Addendum 2
TFM-044-25

PROJECT NAME:
MUN BRUNEAU CENTER FOR RESEARCH AND INNOVATION (IIC) HEATING UPGRADES

Addendum 1
TFM-044-25

LEVEL 2 FLOOR PLAN - NEW VENTILATION LAYOUT

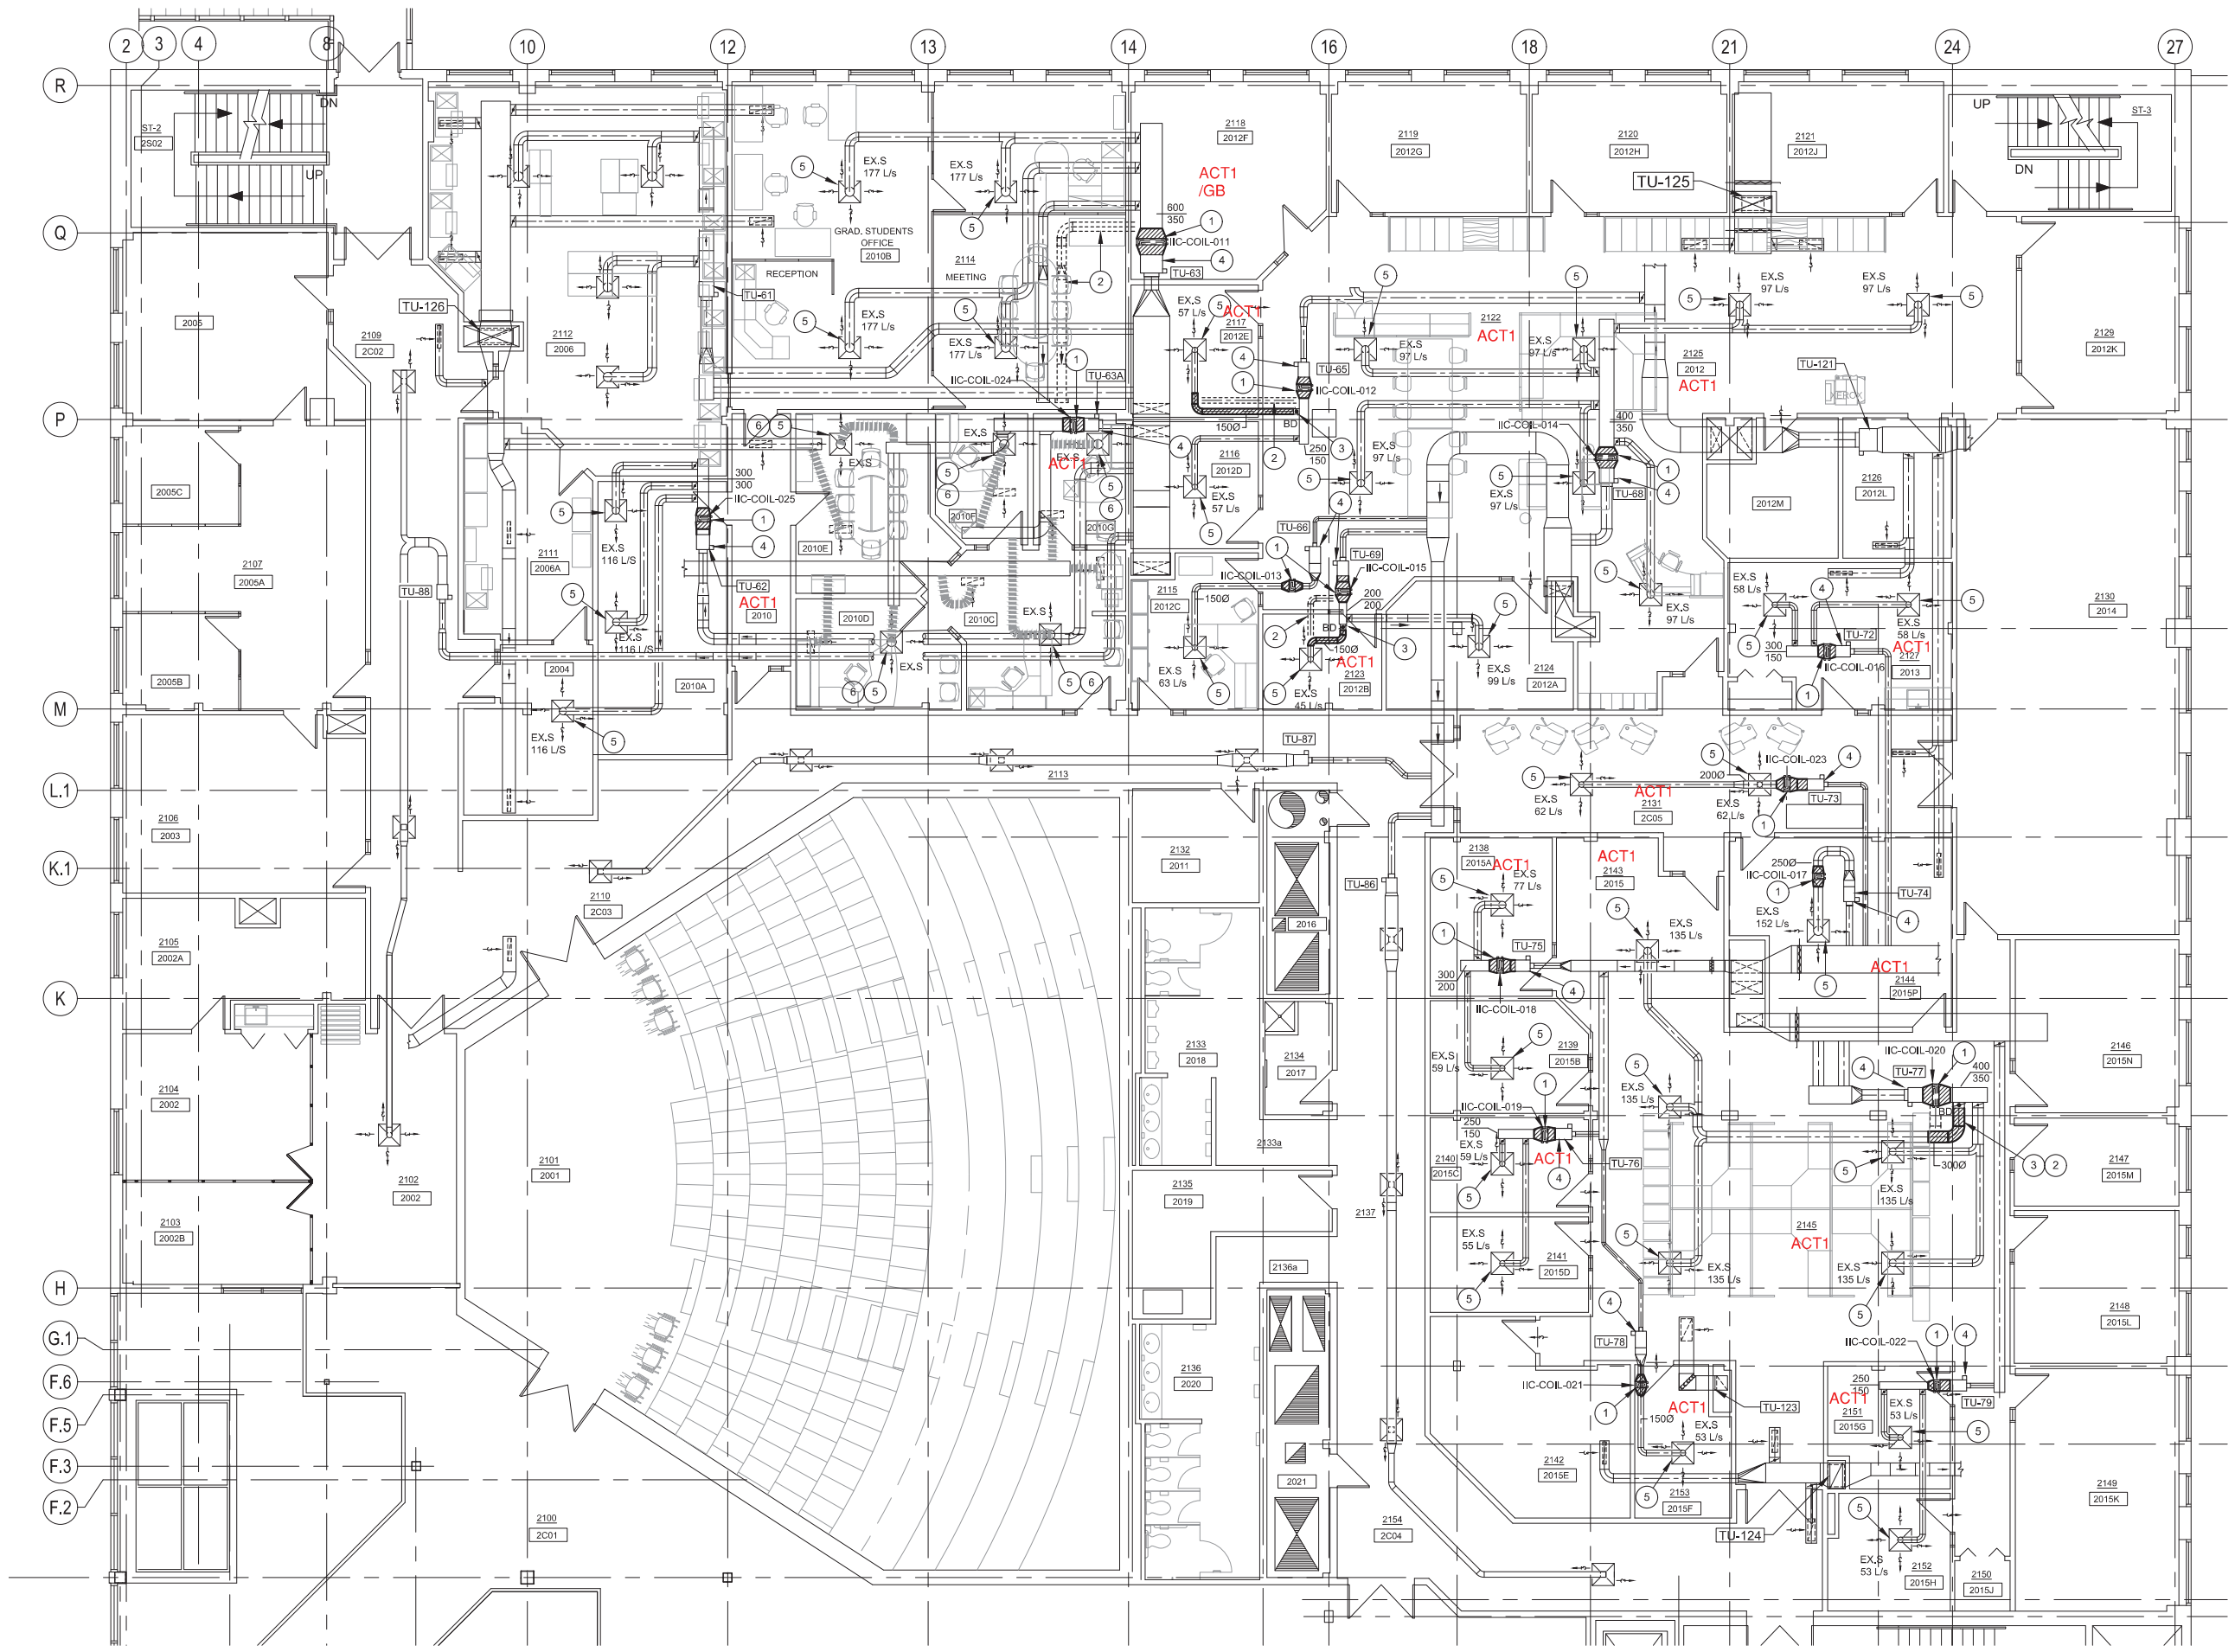
CEILING CLARIFICATION
